June 26, 2026

Mr. Michael Smith
Land Quality Bureau
Iowa Department of Natural Resources
6200 Park Avenue, Suite 200
Des Moines, IA 50321

**RE: Metro Park East Sanitary Landfill – Phase II Unit and CWTS
Permit No. #77-SDP-01-72
Response to Comments on 2025 Annual Water Quality Report (IDNR Document No. 115946)**

EXISTING SITE
UTILITY MAP

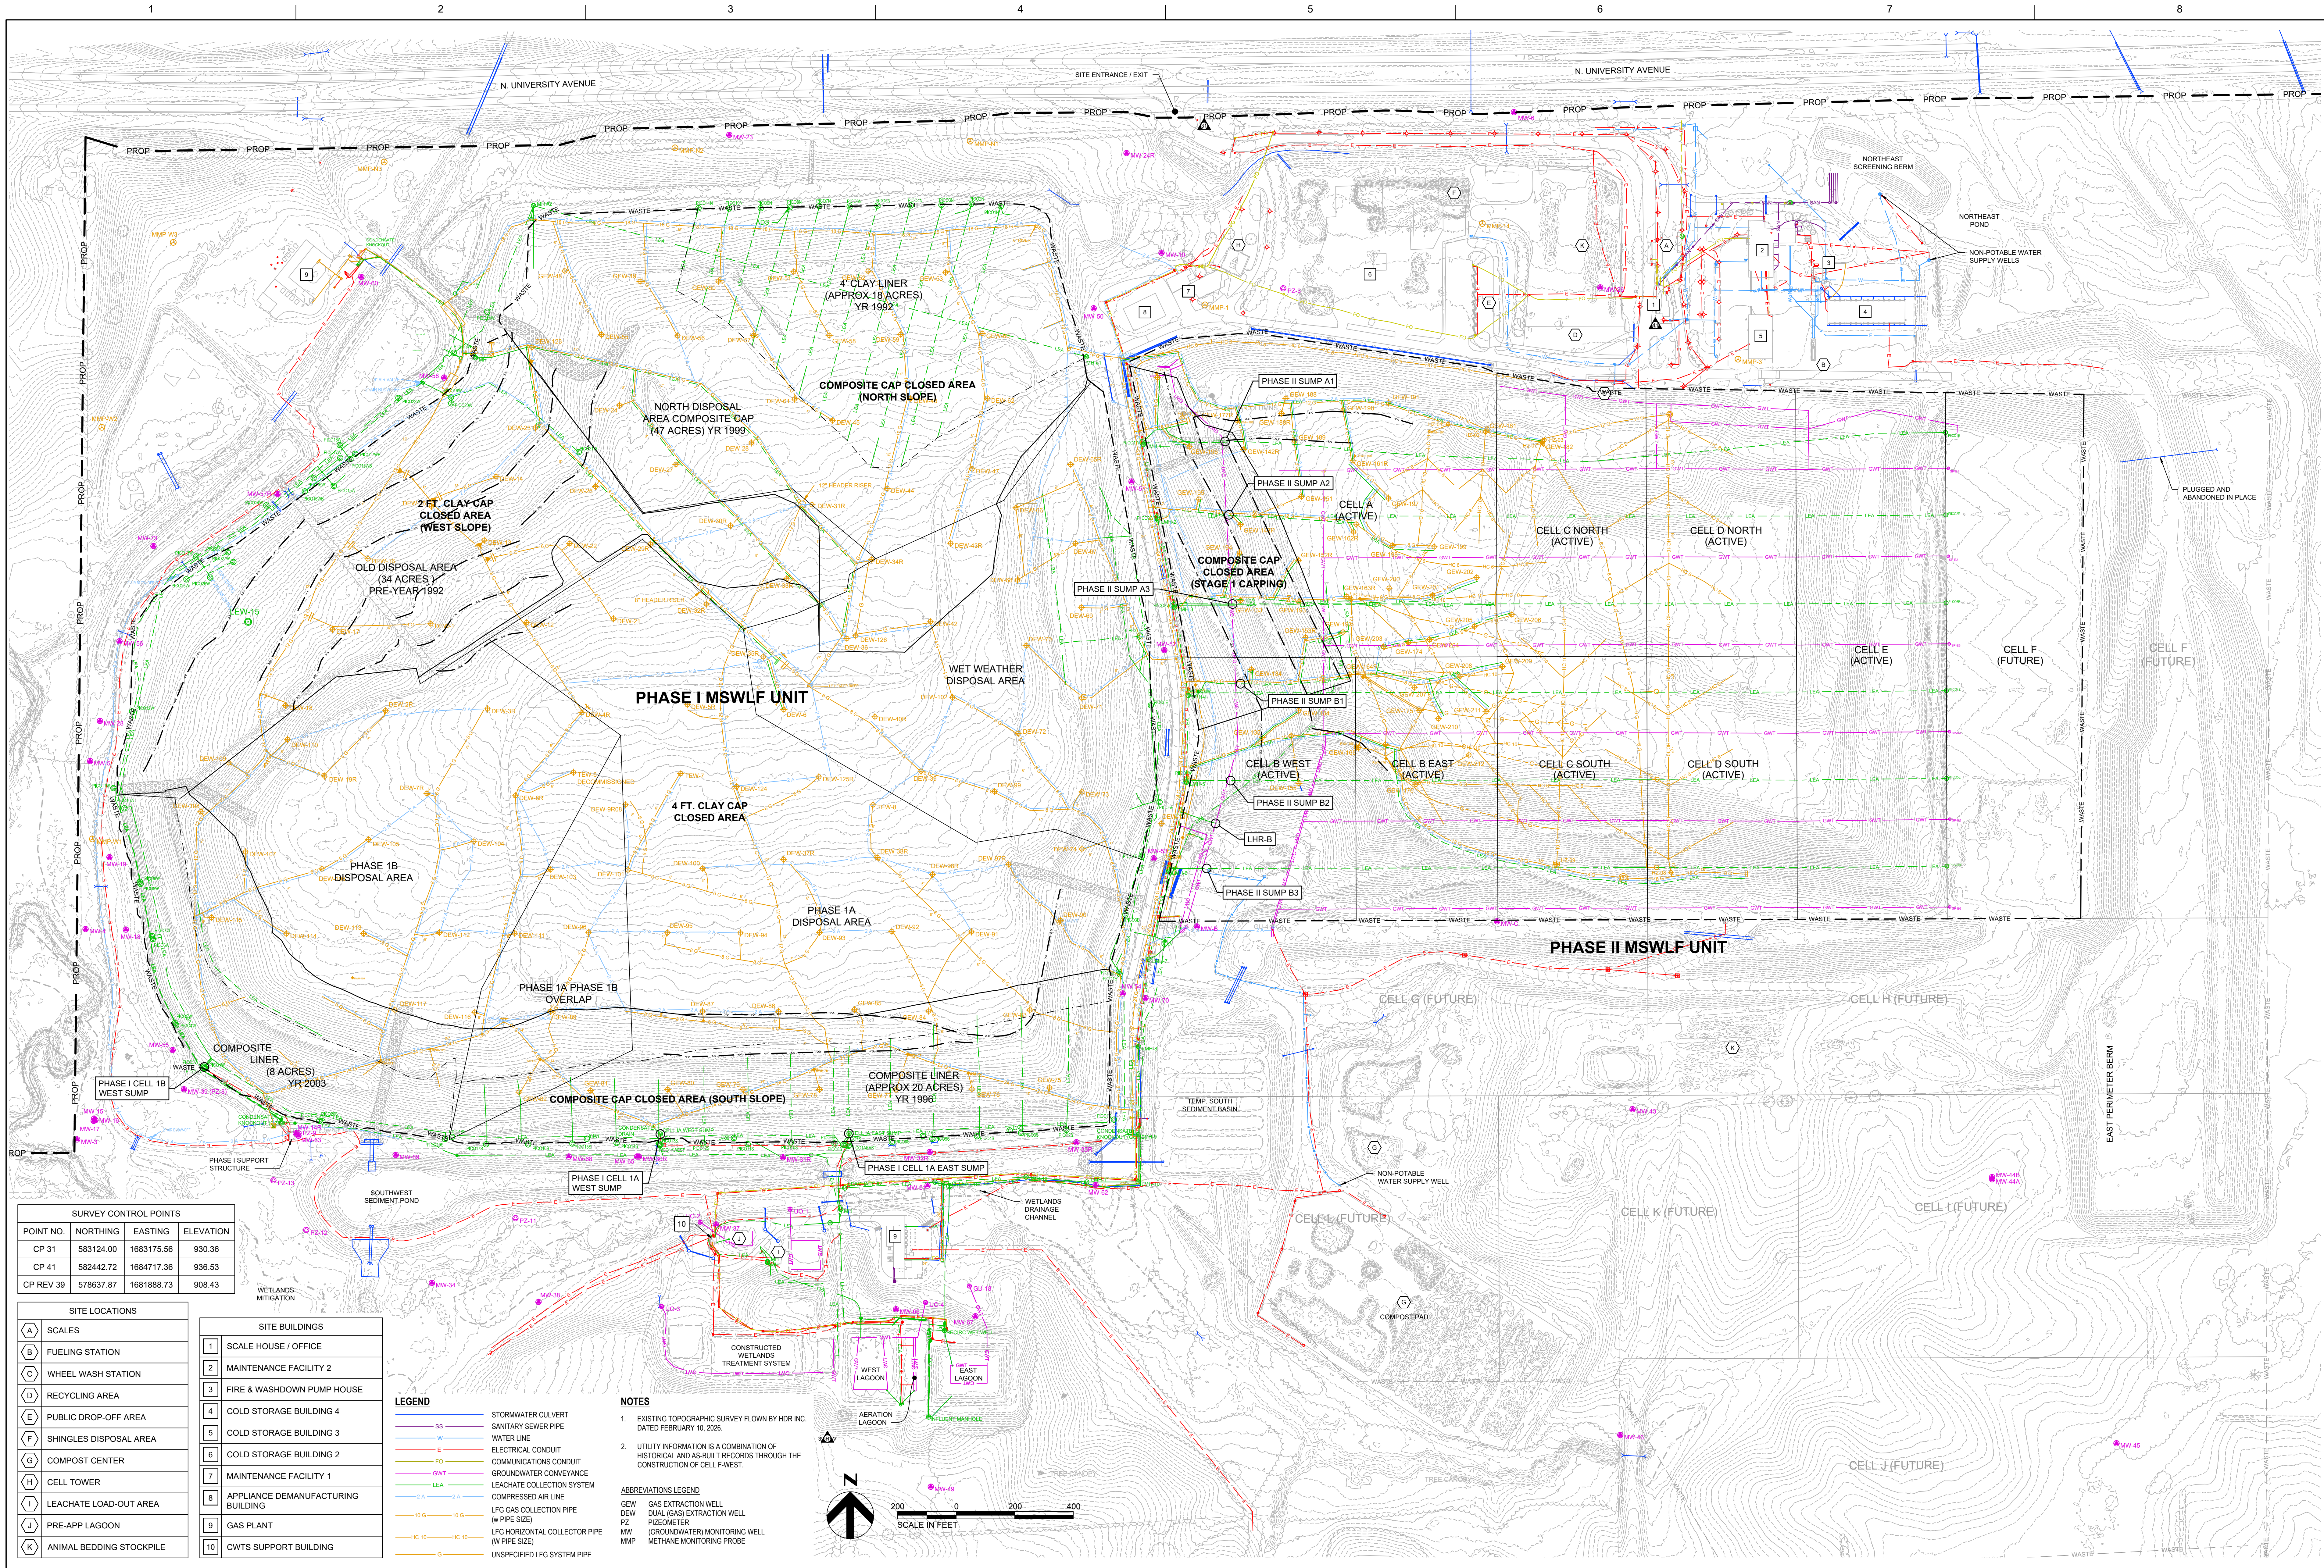
- 1. The DNR appreciates the detailed information and maps to describe the system. However, due to the expansive and complex nature of the system and different nomenclature used by Superior Jetting, Inc. (see Appendix D), it is unclear what lines were inspected and cleaned, if any lines were unable to be inspected and cleaned, if noted blockages or other issues were resolved, and if not resolved, what the proposed resolution is. A summary table or similar, along with a cross-reference for the nomenclature, is requested to clarify these items.*

2. *In addition, the report includes terms, such as AP, HZ, PIA, and PS, but there are not explanations on what these mean nor is it clear where these are on the figures/maps. Related to this, it is unclear if PS1 and PS2 refer to Leachate No. 1 and Leachate No. 2, respectively. Please clarify.*

3. *Lastly, in Appendix B it is unclear on how compliance, less than one foot of head on liner, is achieved. For example, at Phase I Sump 1A East the compliance elevation is approximately 836.5, so the liner elevation is assumed to be one foot lower (i.e. 835.5). However, the leachate head measurements indicate elevations ranging between 826 and 828 during the reporting period, which are below the assumed liner elevation. Please provide additional information and calculations to resolve this apparent discrepancy for this point as well as for the other graphs in Appendix B. In addition, please clarify the location of Phase I Sump 1A East and other sumps on the figures.*

Response: Table 1 is attached which summarizes the identifications of access points for jetting and cleaning of leachate lines at both the Phase I and Phase II areas at the site. The locations of the access points for jetting equipment are summarized on Table 1 with grid coordinates which are applicable to the attached Figure 1.

Response: To address terms and acronyms, a table will be included in each future Leachate Collection System Performance Evaluation Report (LCSPER) for MPE summarizing the definitions and descriptions. For the 2025 LCSPER, the terms and acronyms are defined and described on the attached Table 2 to this letter. Terms and acronyms that define a feature or structure at the MPE Landfill are depicted on the attached Figure 1.

For reference, the Graphs from Appendix B of the 2025 LCSPER have been attached to this document with updates indicating either the bottom of the sump or transducer measurement elevation and the common liner elevation where waste is deposited adjacent to the sumps. For spatial reference, the locations of the Phase I and Phase II sumps and LHR-B are depicted on the attached Figure 1.
